**STAFF REPORT**  
**(One-Step Final Plat)**

**CASE NUMBER:** SUB 2000-03 -- WILLOW PLACE ADDITION

**OWNER/APPLICANT:** BuildTech 2000, LLC; Attn: Jerry Michaelis, 3500 N. Rock Road, Bldg. 400, Wichita, KS 67226

**SUB 2000-03 -- One-Step Final Plat of WILLOW PLACE ADDITION**  
**March 9, 2000 - Page 2**

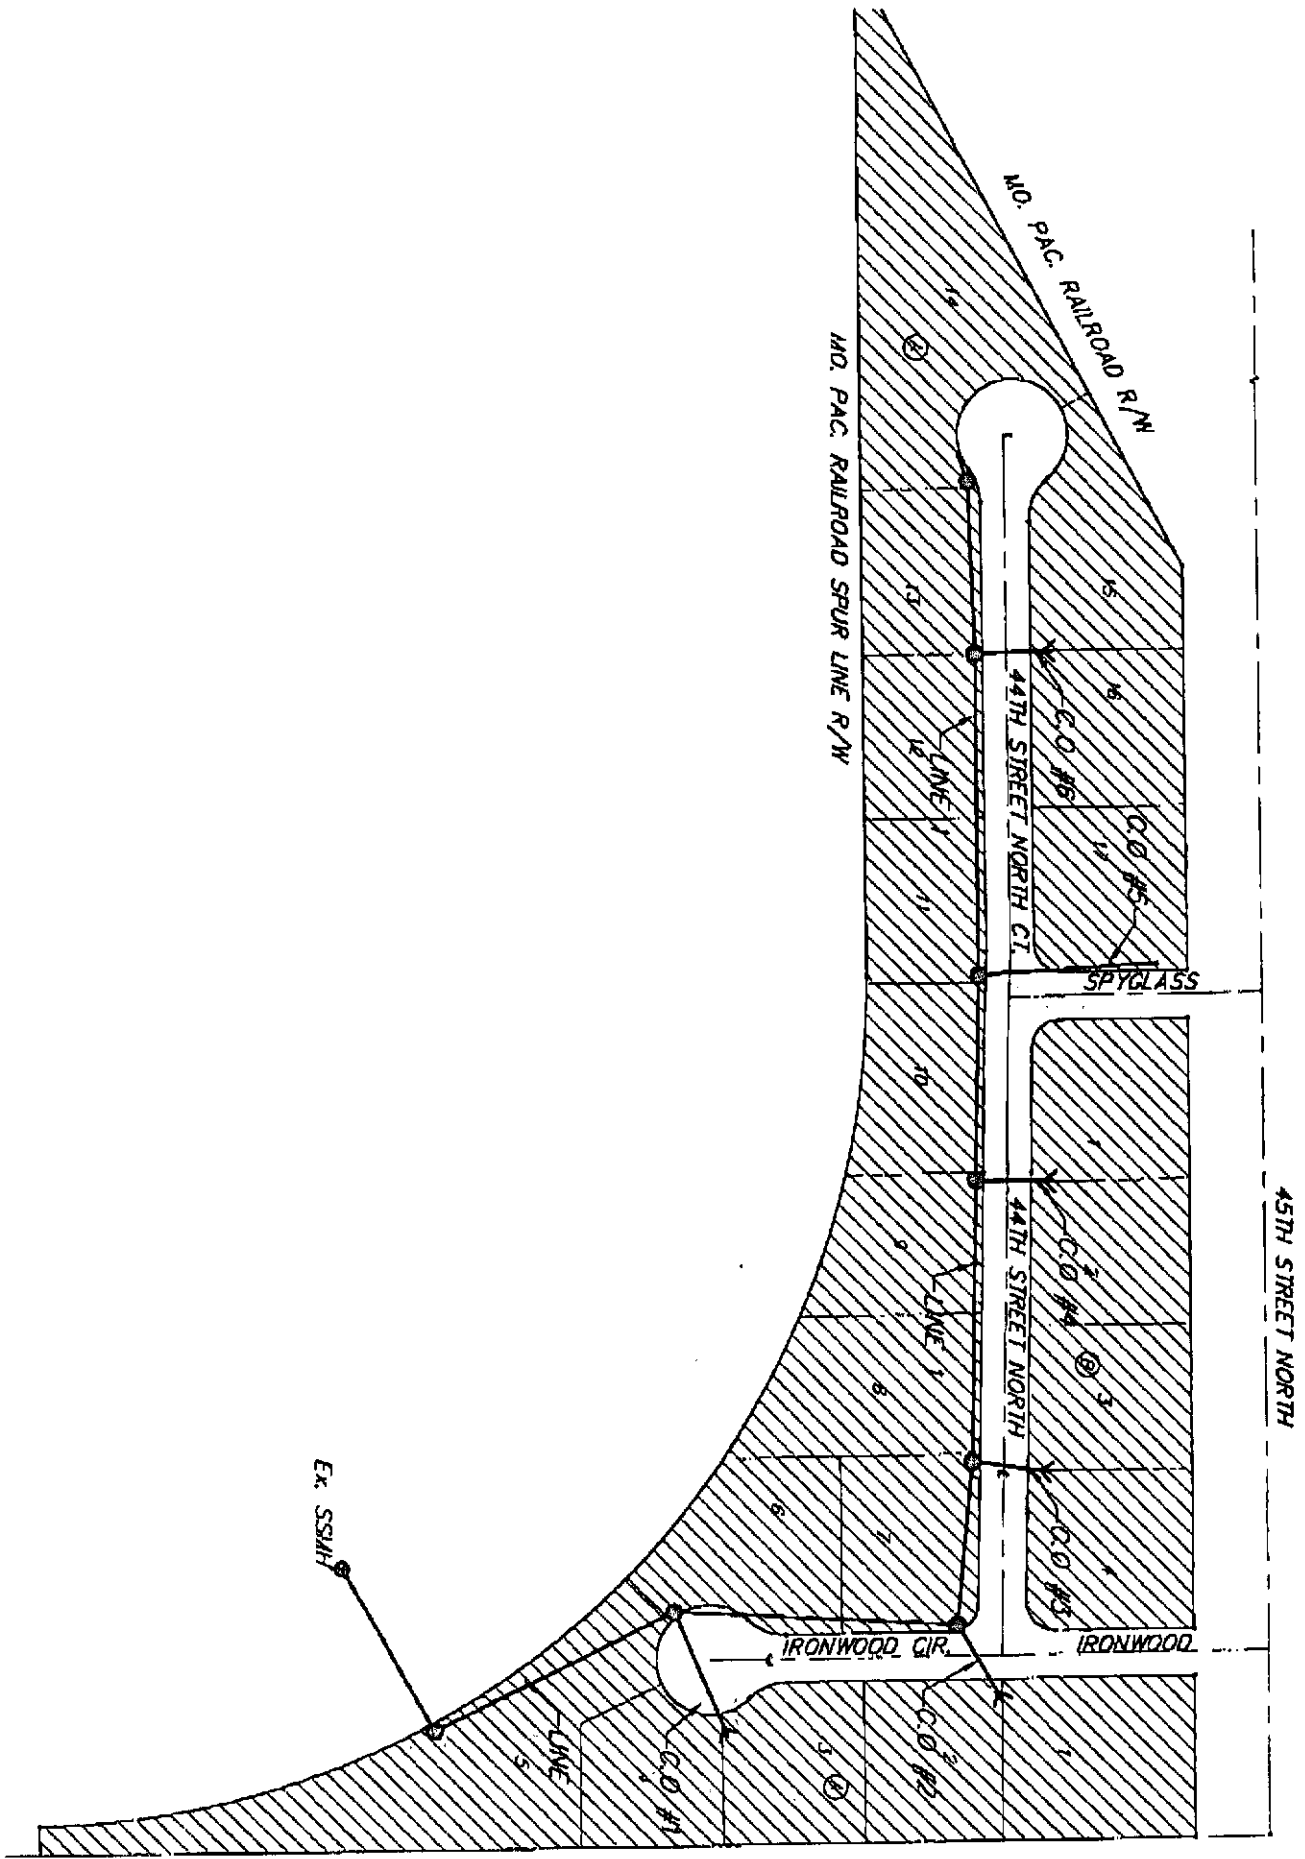
- A. The Applicant shall guarantee extension of sanitary sewer and City water. City Engineering needs to comment on the need for additional guarantees or easements.

- C. City Engineering needs to comment on the status of the applicant's drainage plan.
- D. County Engineering requests the submission of a drainage plan for review.

- E. The plat shall dedicate complete access control along the site's frontage to 45<sup>th</sup> St. North. The access controls shall be referenced in the plat's text.

- H. City Fire Department needs to comment on the acceptability of the street names. Willowplace should be revised to 44<sup>th</sup> St. North.
- I. Since this plat proposes the platting of narrow street right-of-way with adjacent "15-foot street drainage and utility easements", a restrictive covenant shall be submitted which calls out restrictions for lot-owner use of these easements. Retaining walls and change of grade shall be prohibited within these easements as well as fences, earth berms and mass plantings.

- J. The applicant shall submit a copy of the instrument which establishes the pipeline easements on the property, which verifies that the easements shown are sufficient and that utilities may be located adjacent to and within the easements.

- K. The applicant's agent shall determine any setback requirements for the pipelines by researching the text of the pipeline agreements. If a setback from the pipeline easements is provided for in the pipeline easement agreements, it shall be indicated on the face of the plat.

- L. The building setback lines may be eliminated from the area located within the pipeline easement.
- M. Block numbers need to be designated.
- N. The bearing along the north section needs to be corrected.

- O. Since this plat is not a replat, the surveyor's text should not include reference to KSA 12-512(b).
- P. Traffic Engineering should comment on the need for improvements to 45<sup>th</sup> St. North.
